Product Equality Declaration

We, Rhino Mobility LLC, declare on our sole responsibility for the products' change on C65 (initial) and C65R (variant) have the same electrical characteristics, but the differences between them is the antenna design and battery capacity, the other RF specifications are same and conducted performance are same setting. Details as below:

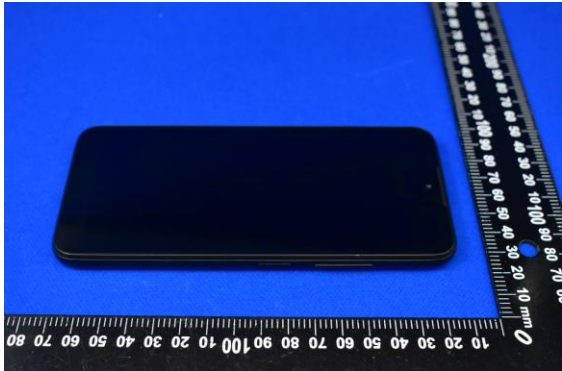
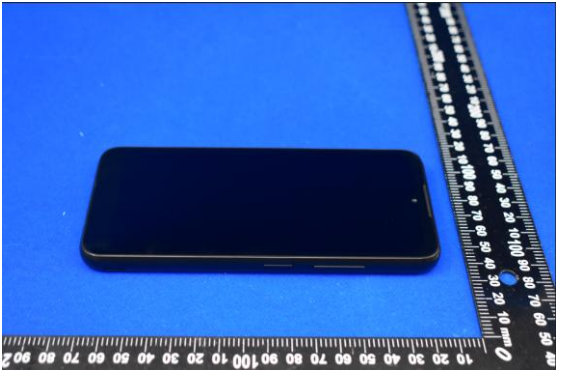
Item	Initial	Variant
Model	C65	C65R
FCC ID	2AUOUC65	2AUOUC65R
RF Chipset	WWAN: SDR-435-0-PSP209-TR-02-0 WLAN: WCN-3988-0-82BWLSP-TR-00-0	WWAN: SDR-435-0-PSP209-TR-02-0 WLAN: WCN-3988-0-82BWLSP-TR-00-0
WCDMA/LTE/ NR Bands WLAN	WCDMA: Band 2/4/5; LTE: B2/4/5/7/12/13/14/17/18/19/25/26/29/30/38/41/48/ 66/71; NR: n2/5/7/25/26/29/30/41/48/66/71/77/78 BT/WIFI 2.4&5G/NFC	WCDMA: Band 2/4/5; LTE: B2/4/5/7/12/13/14/17/18/19/25/26/29/30/38/41/48/ 66/71; NR: n2/5/7/25/26/29/30/41/48/66/71/77/78 BT/WIFI 2.4&5G/NFC
Photos

HW Description		
HW Infor.	PCB& PCBA	All the same.
	Battery	C65: 3950 mAh C65R: 4000 mAh
	Antenna	Redesign
	Back cover	C65: with pogo pin C65R: without pogo pin
SW description		
SW Same	Mode m/RF	All WWAN/WLAN RF conducted performance are same setting.
SW Diff.	Mode I&FCC ID	Only the model number and FCC ID information are displayed differently.
